Re: Pocono Mountains Municipal Airport (MPO) Annual Safety Inspection

On October 25, 2018, an airport safety inspection and Airport Master Record (5010) update were conducted at the Schuylkill County Airport. This letter outlines the findings by our regional Aviation Safety Specialist, Mr. John Logan, and includes a copy of the updated Airport Master Record (Form 5010-1) for your review.

Pocono Mountains
Rwy 23
(left side)

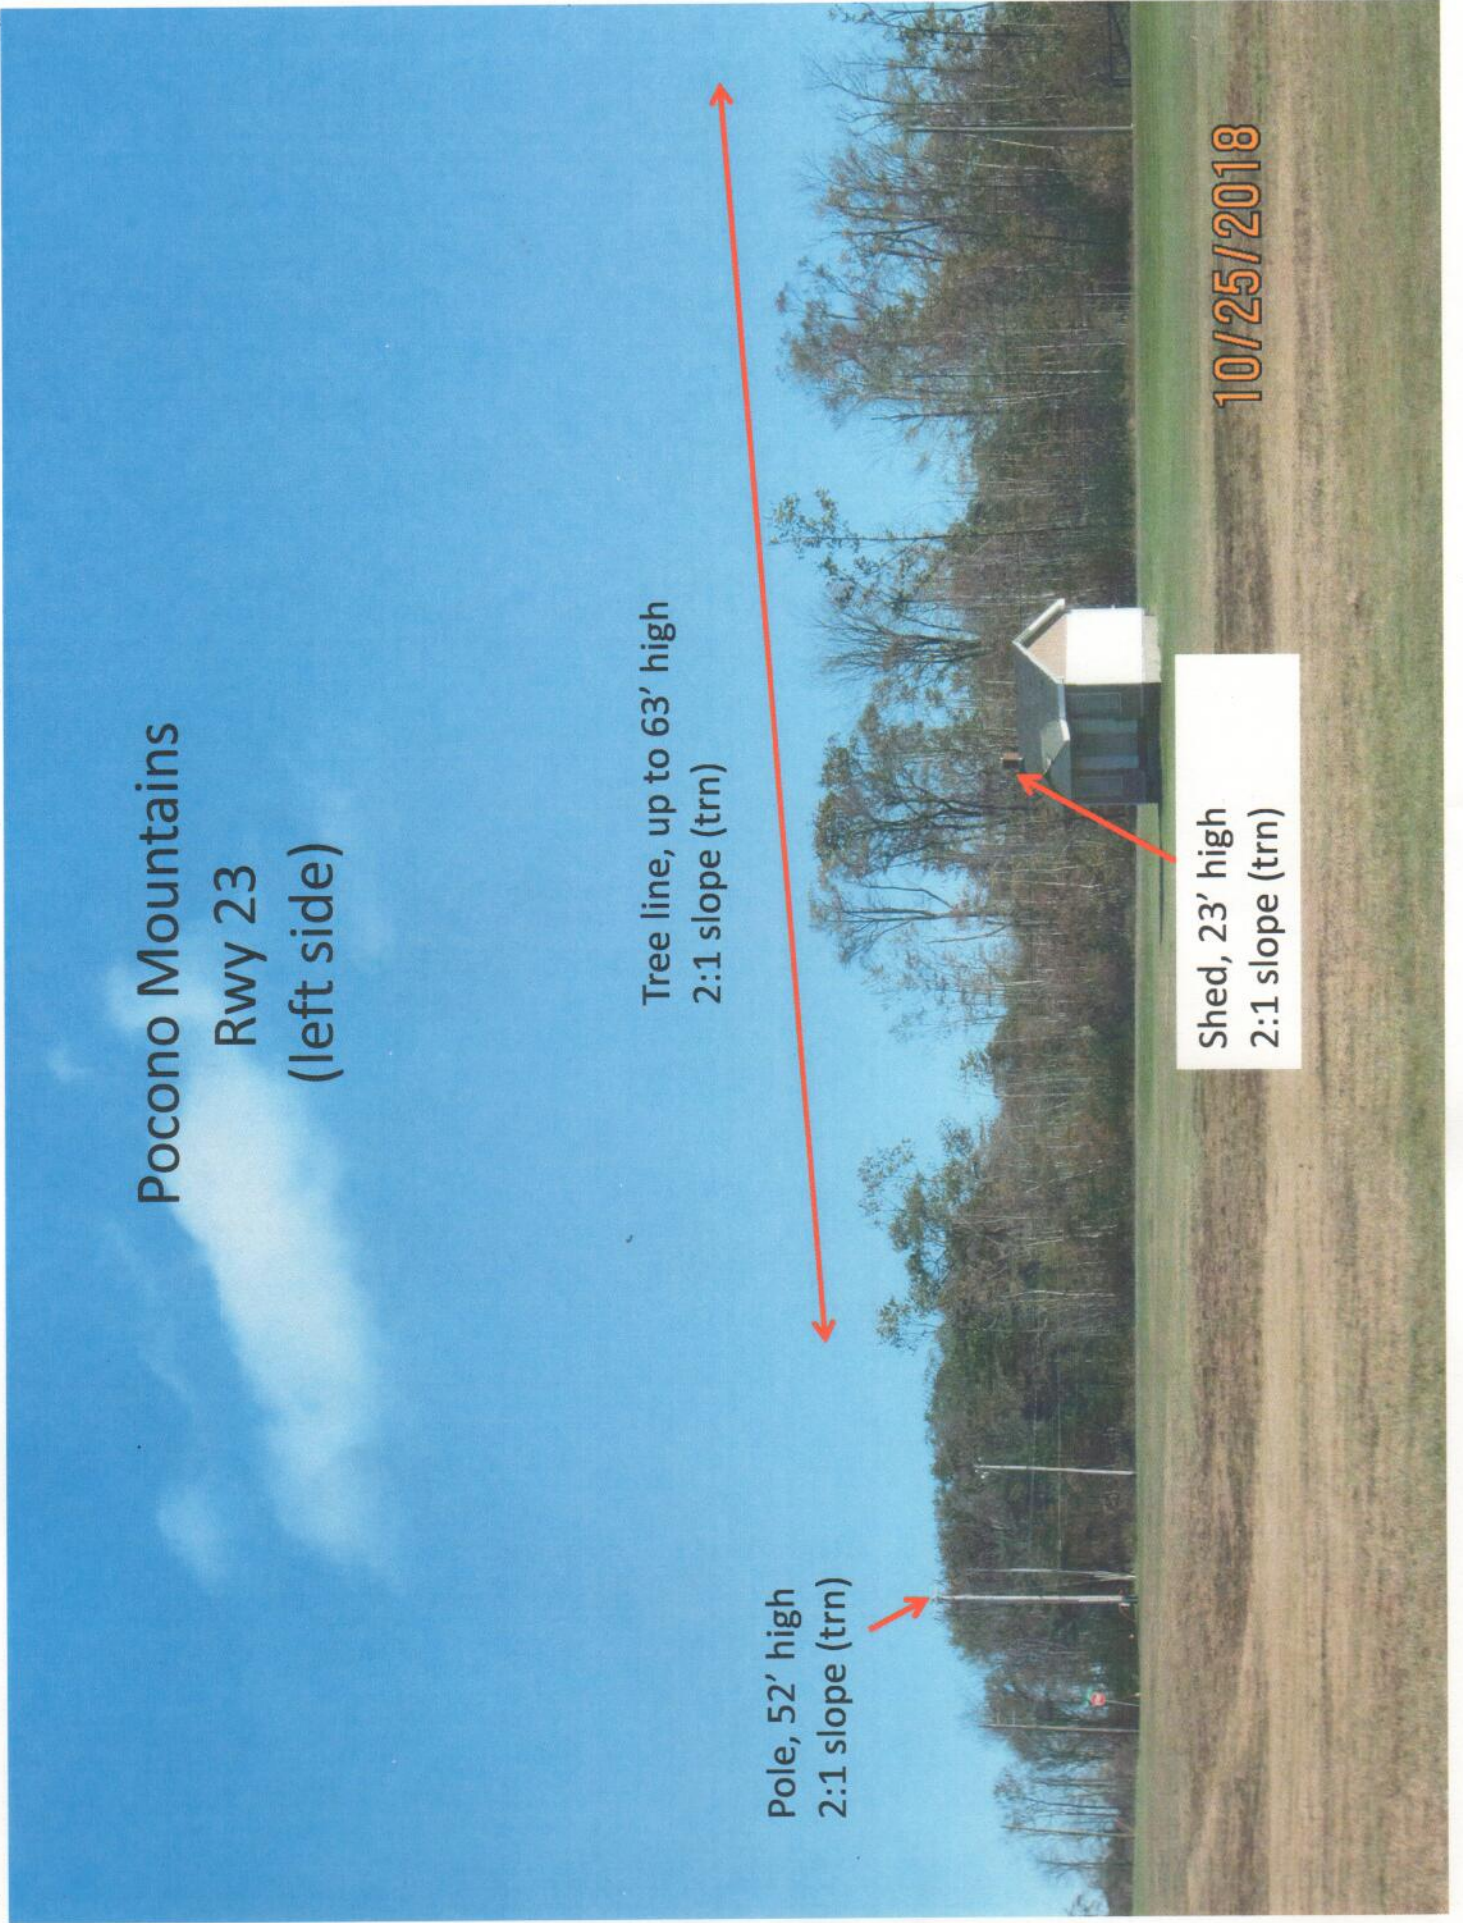
Pole, 52' high
2:1 slope (trn)

Tree line, up to 63' high
2:1 slope (trn)

Shed, 23' high
2:1 slope (trn)

Pocono Mountains
Rwy 31

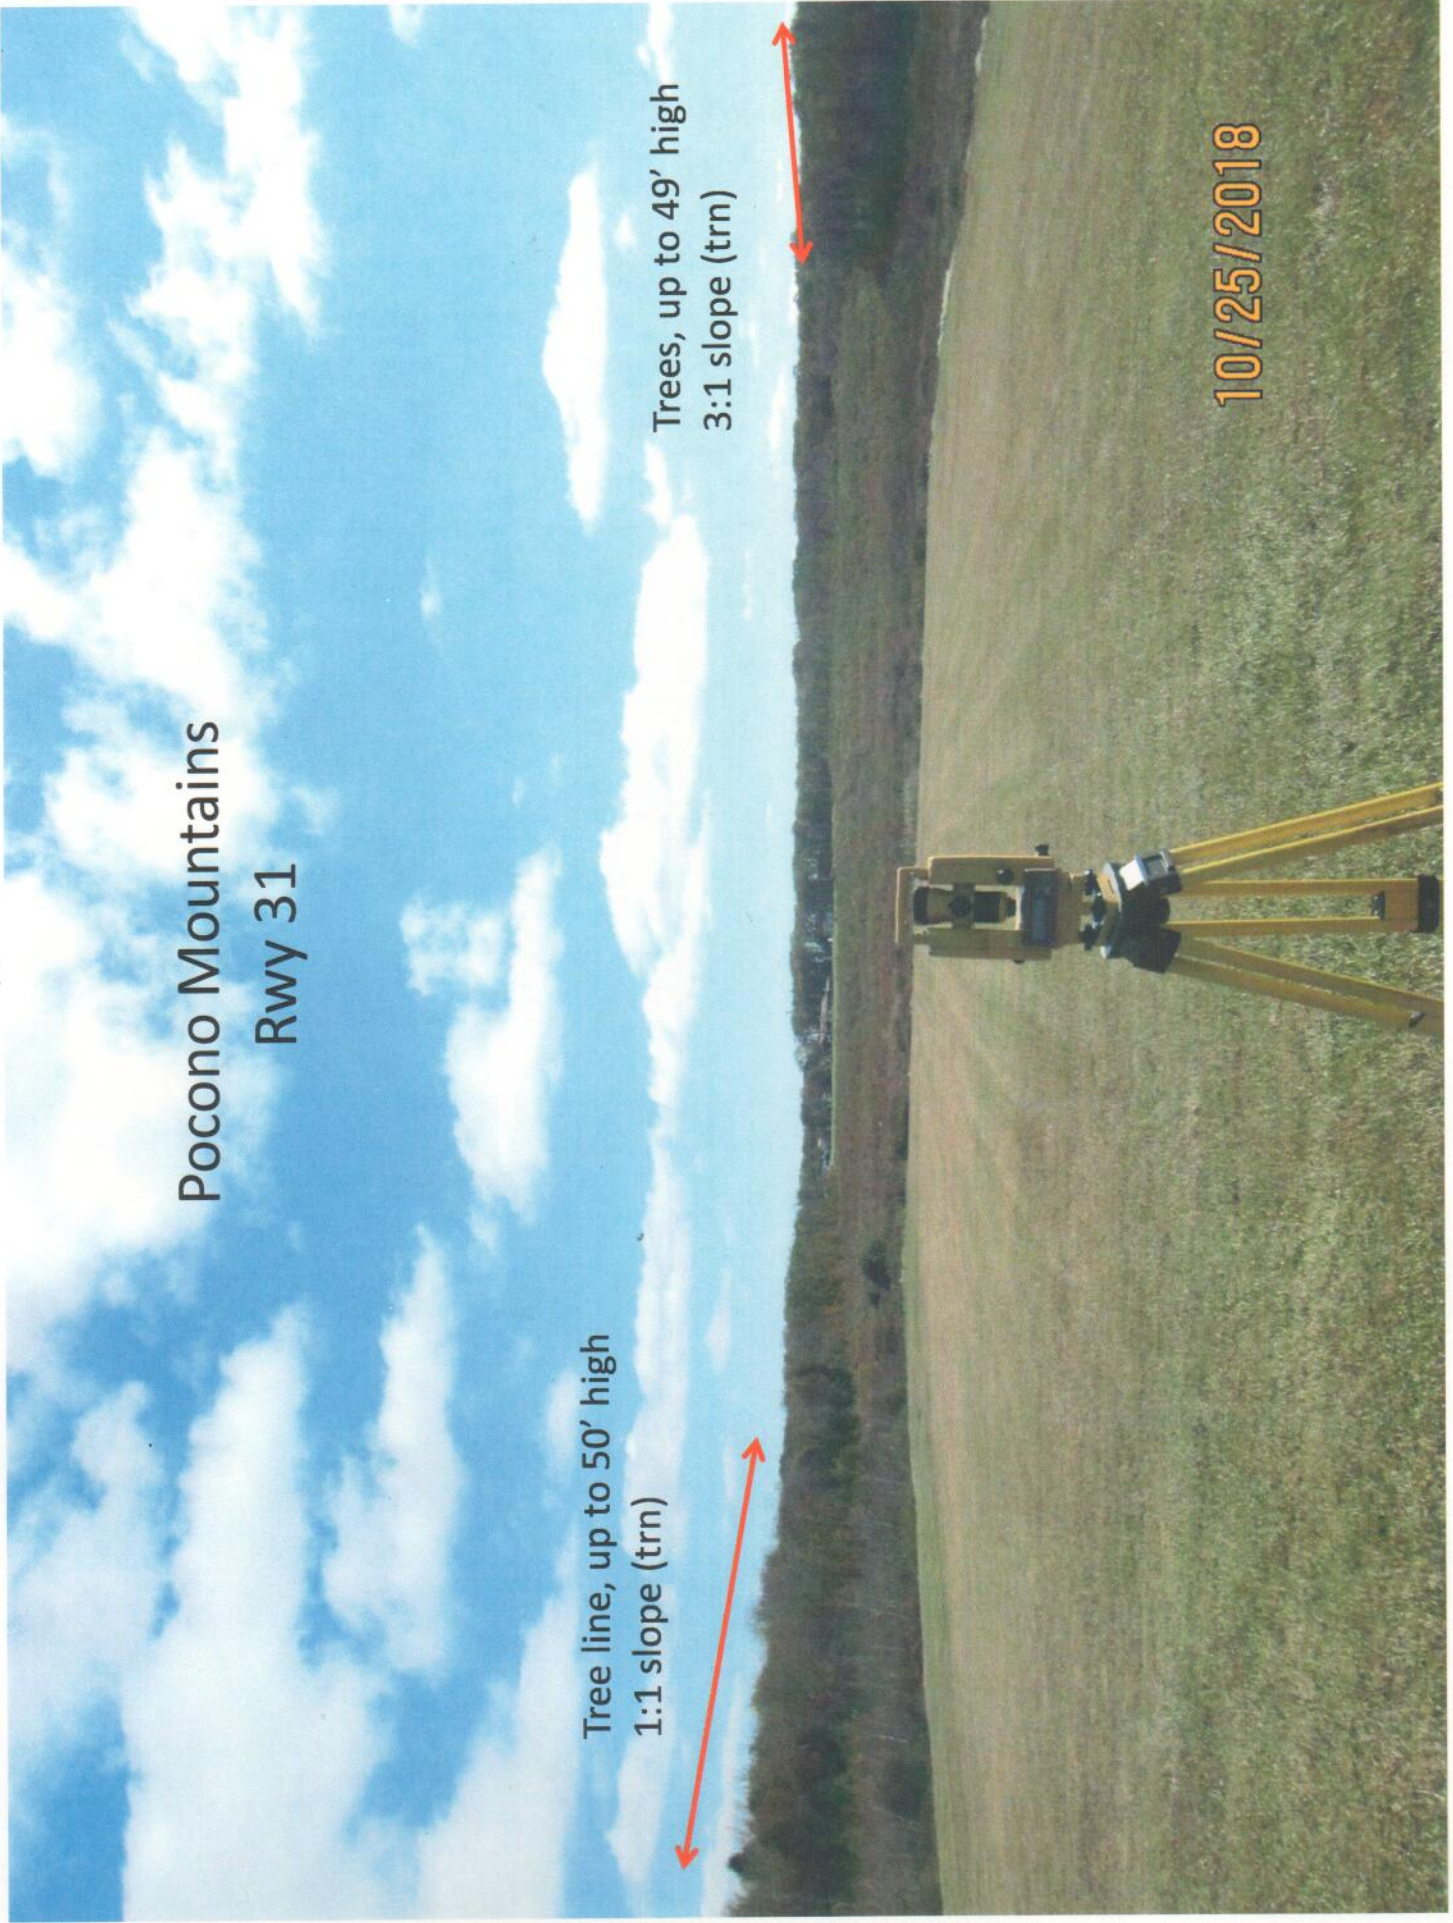
Tree line, up to 50' high
1:1 slope (trn)

Trees, up to 49' high
3:1 slope (trn)

Pocono Mountains
Rwy 31
(right side)

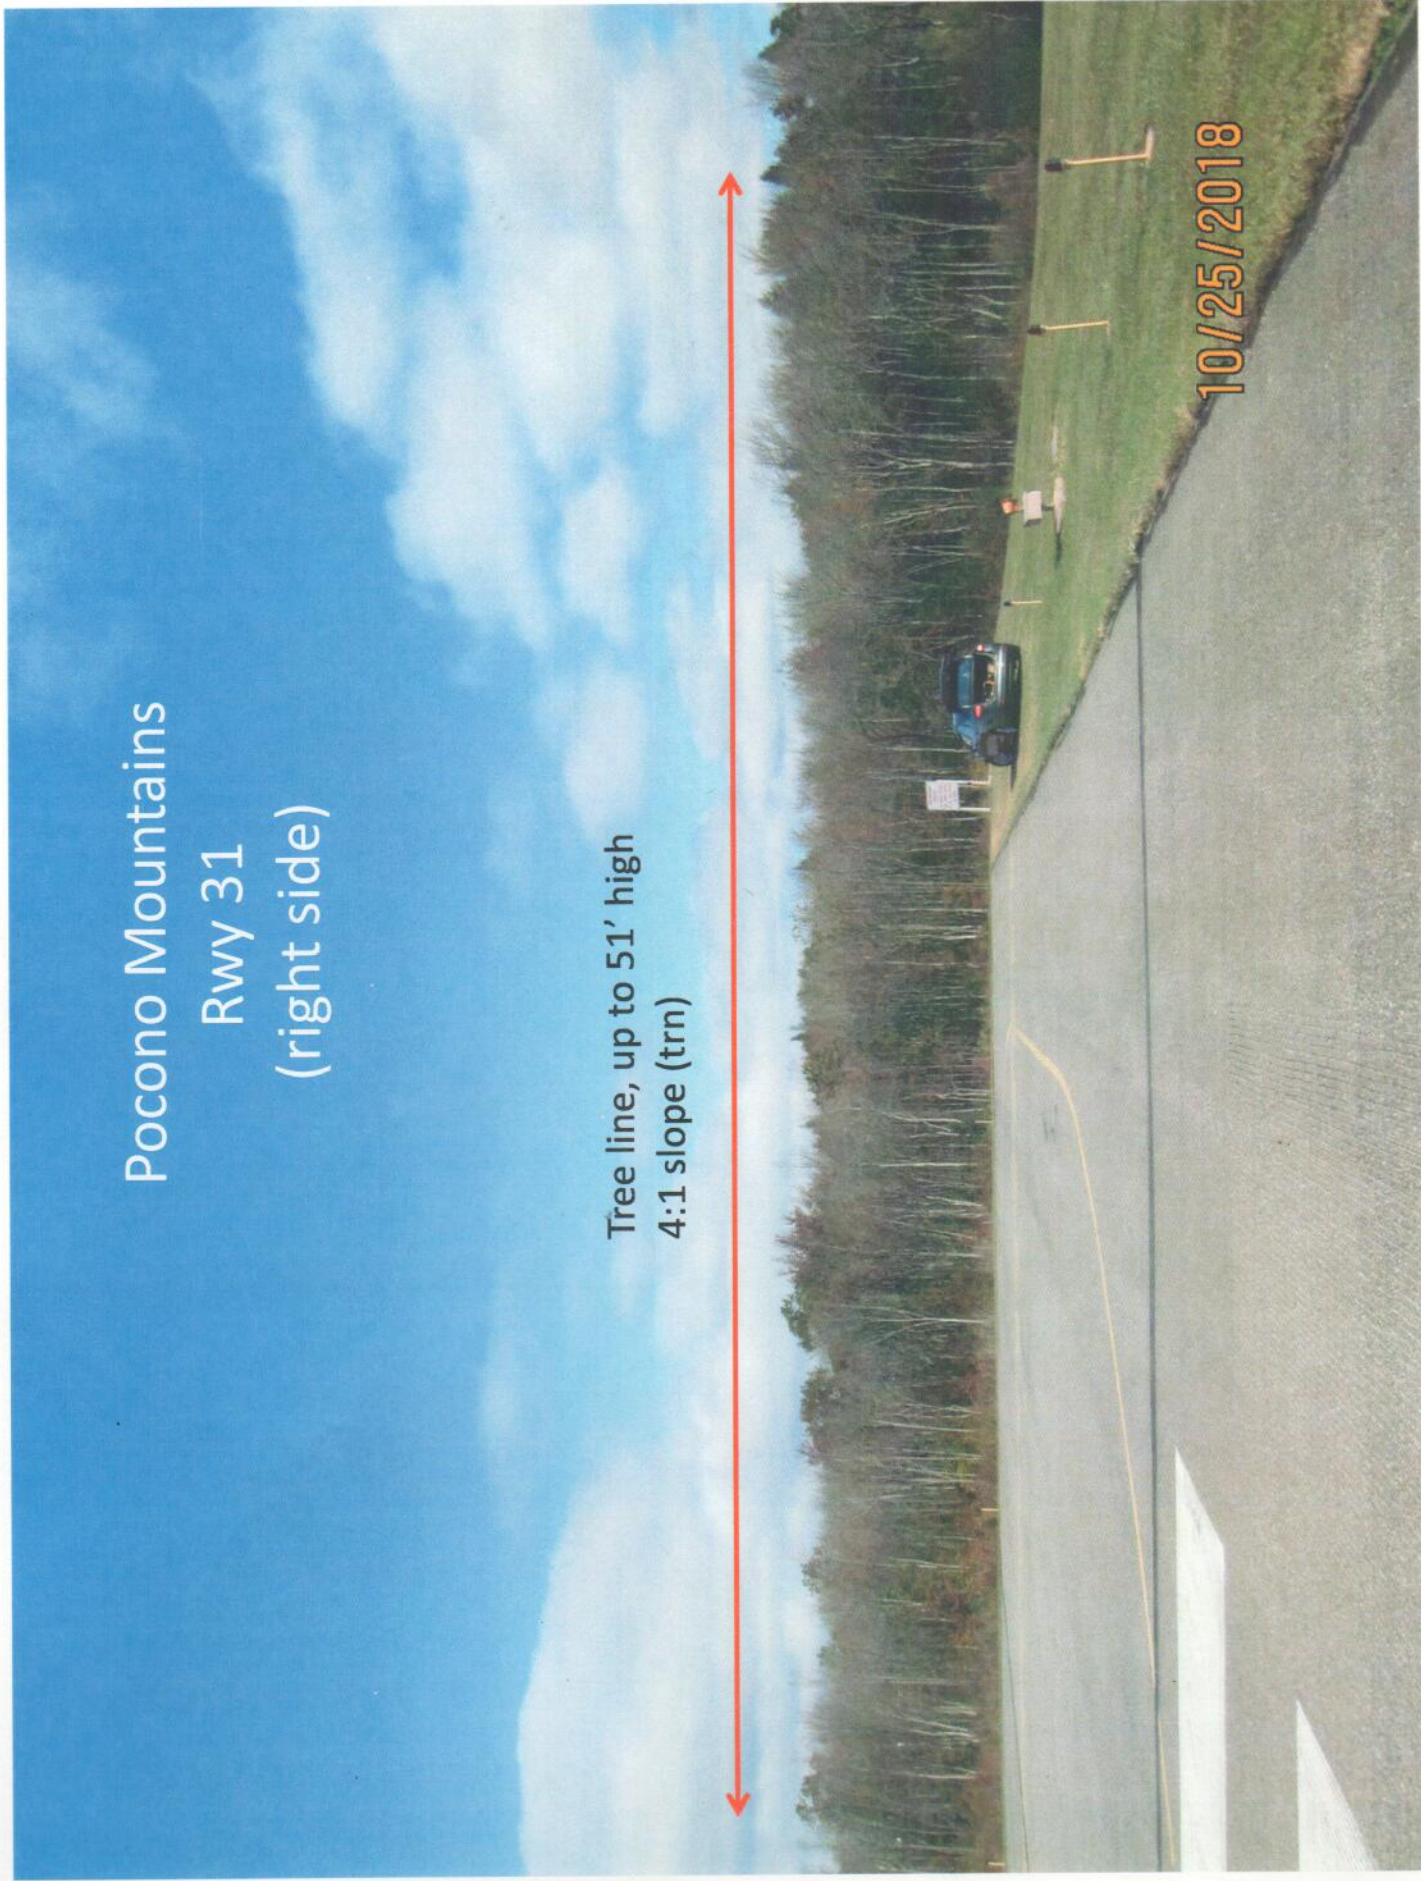
Tree line, up to 51' high
4:1 slope (trn)

Rwy 5

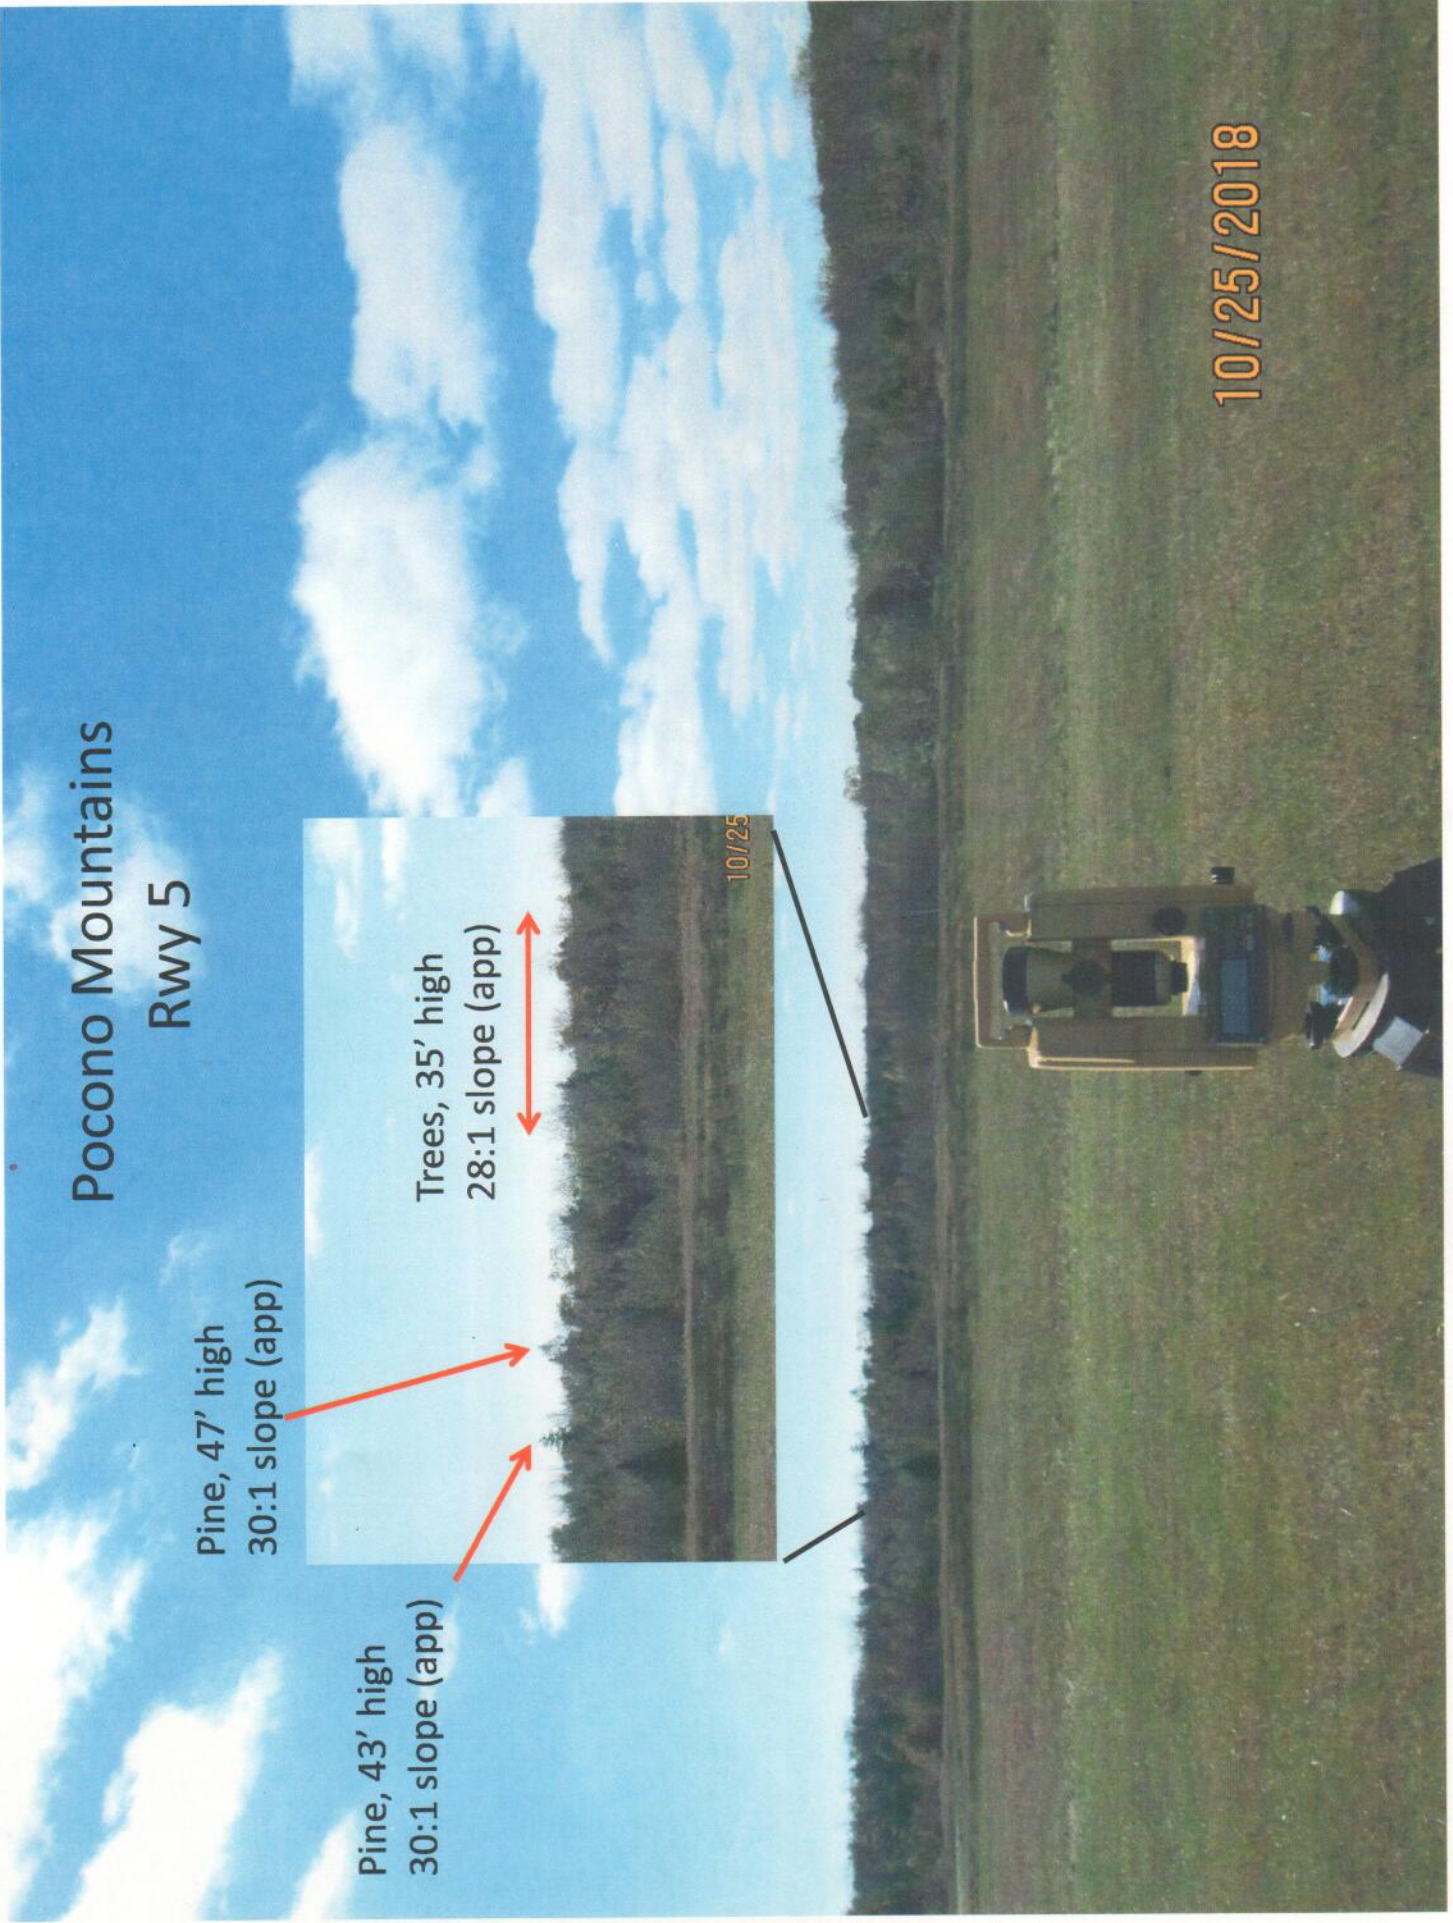
Pine, 47' high
30:1 slope (app)

Pine, 43' high
30:1 slope (app)

Trees, 35' high
28:1 slope (app)
